Client
Kings Keeley Limited C/o Clearbell Capital LLP
Project
65 Kingsway - Base Scheme

Proposed Section EE				
Status	Purpose of issue		RIBA stage	
S2	For Planning		2	
Project No.	Drawn	Checked	Scale	Rev.
1914	FB	TJ	1:100 @ A1 1:200 @ A3	P8

1914-BG-01-ZZ-DR-A-20.255

EE
20.202
Proposed Section EE
1:100@A1, 1:200@A3

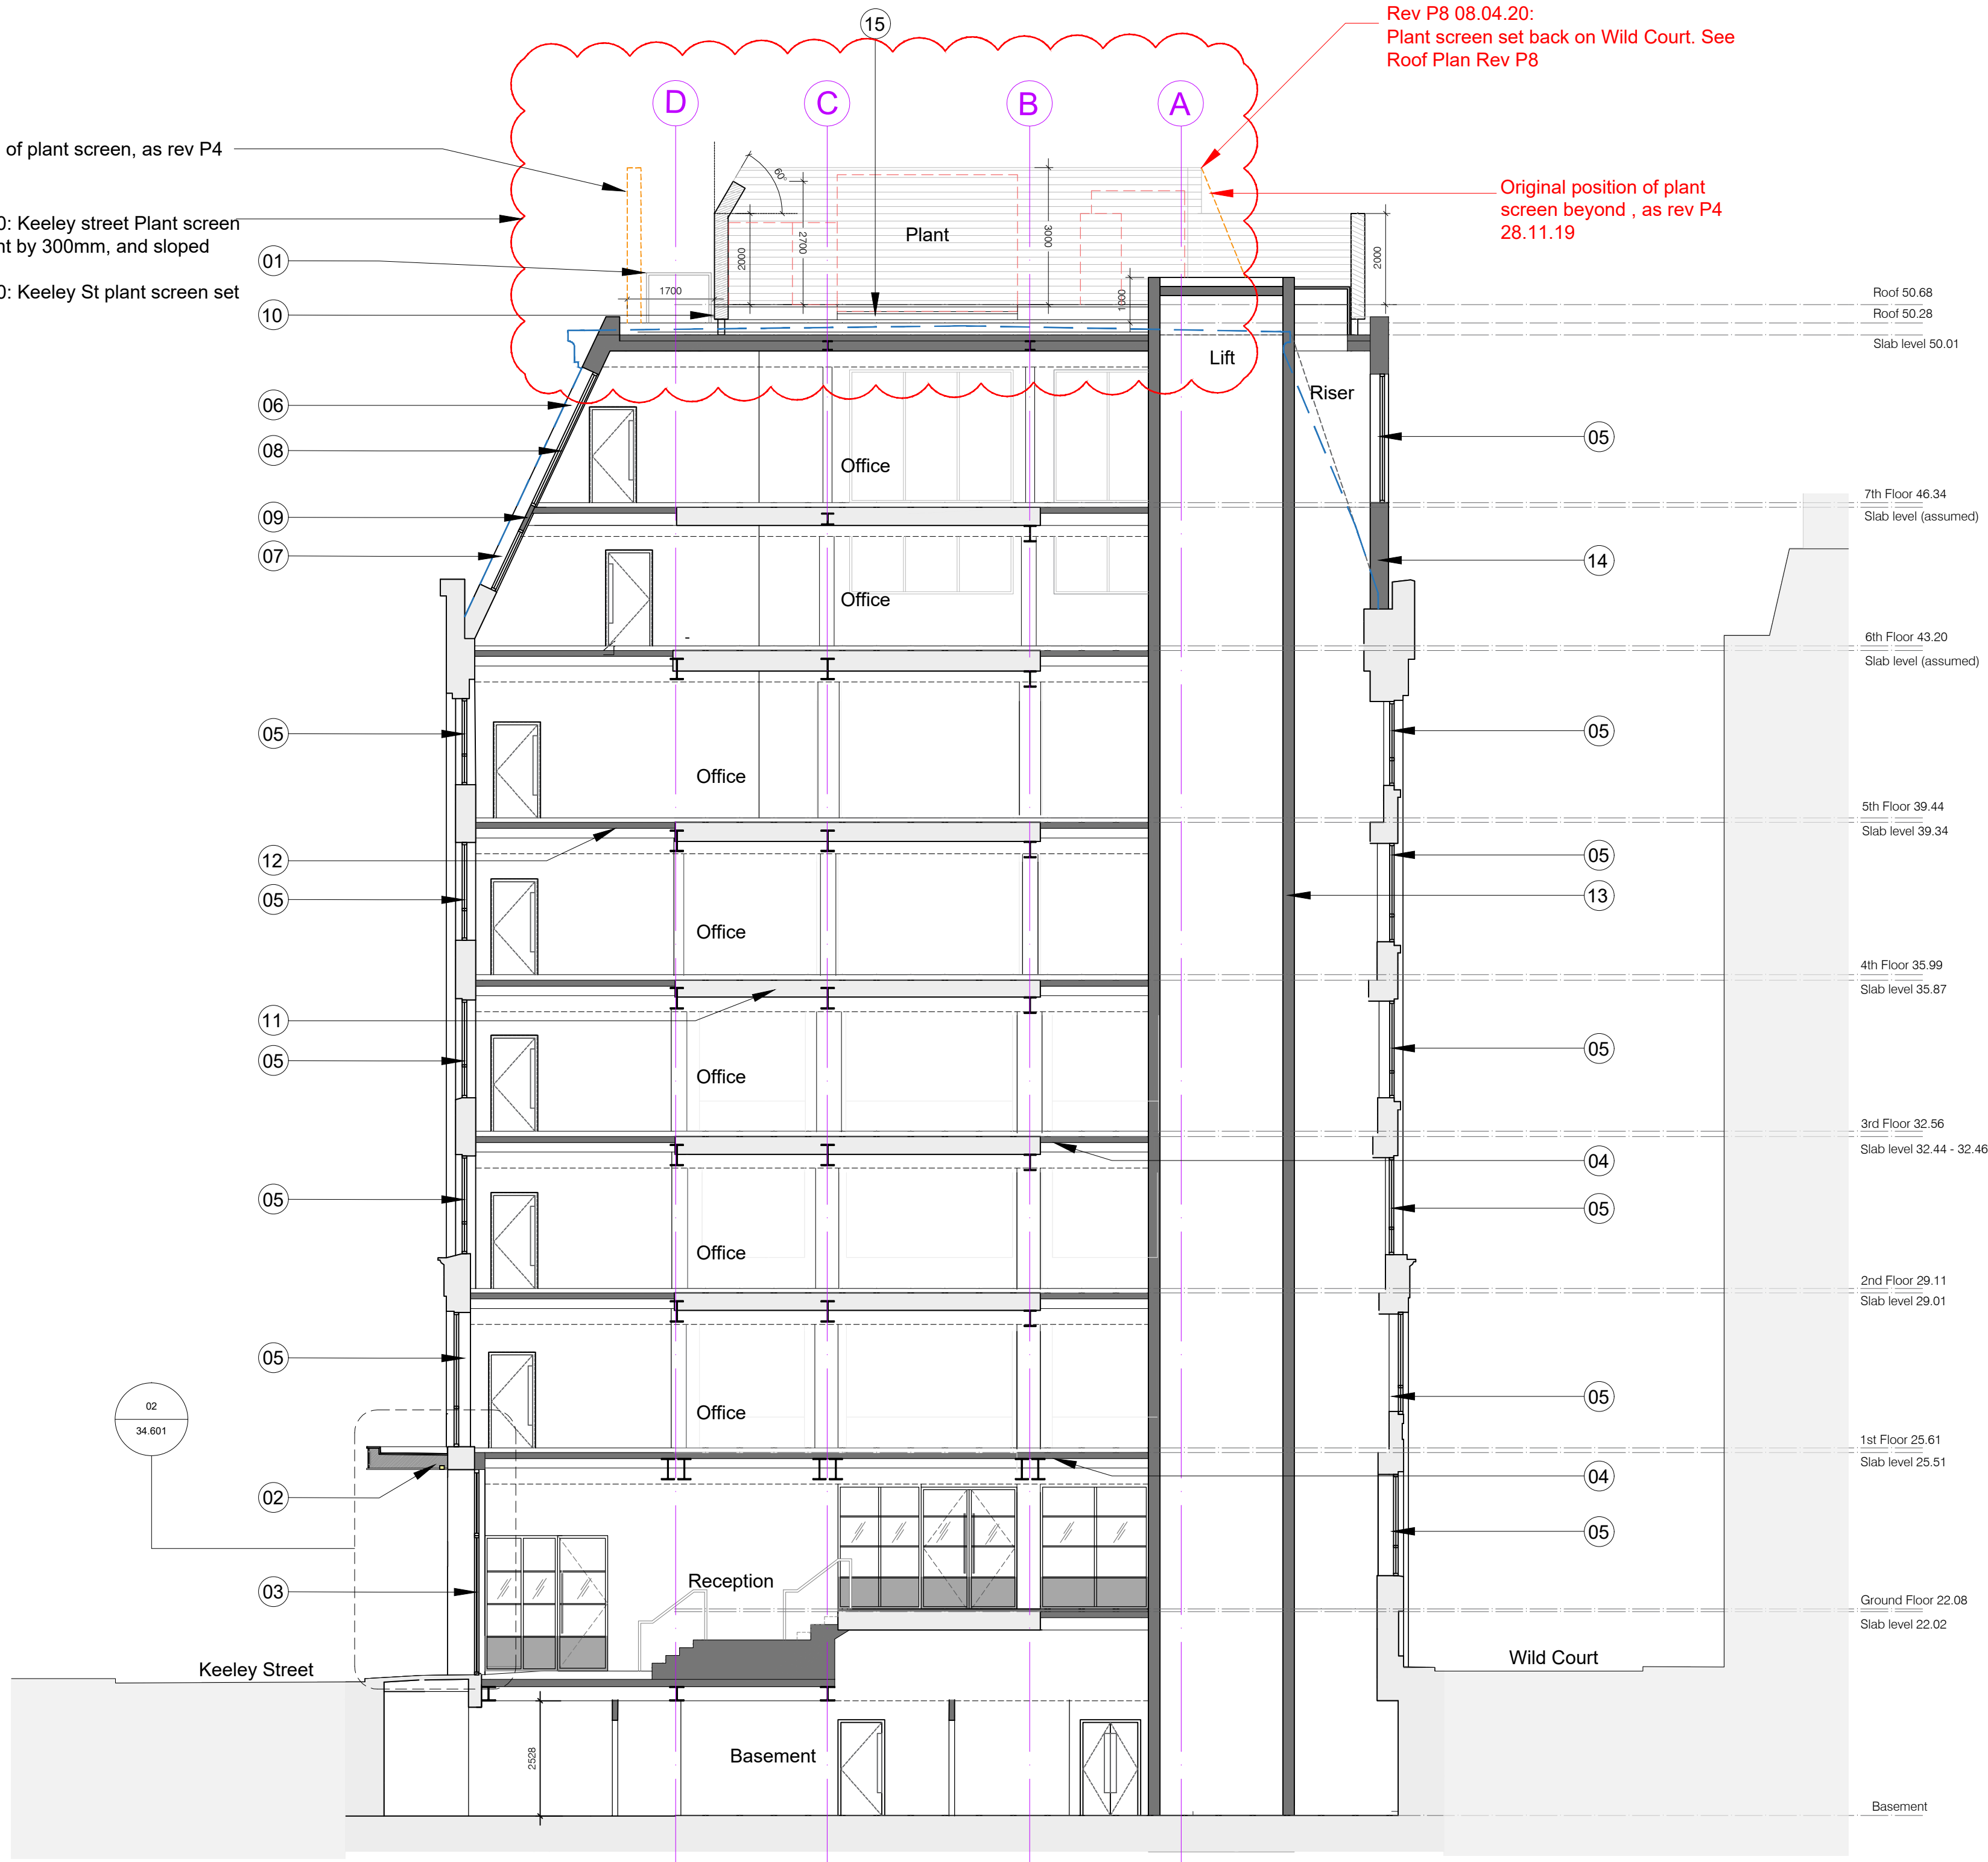
Original position of plant screen, as rev P4 28.11.19

Rev P5 06.03.20: Keeley street Plant screen reduced in height by 300mm, and sloped above 2m.

Rev P6 18.03.20: Keeley St plant screen set back 1.7m

Rev P8 08.04.20:
Plant screen set back on Wild Court. See Roof Plan Rev P8

Original position of plant screen beyond , as rev P4 28.11.19
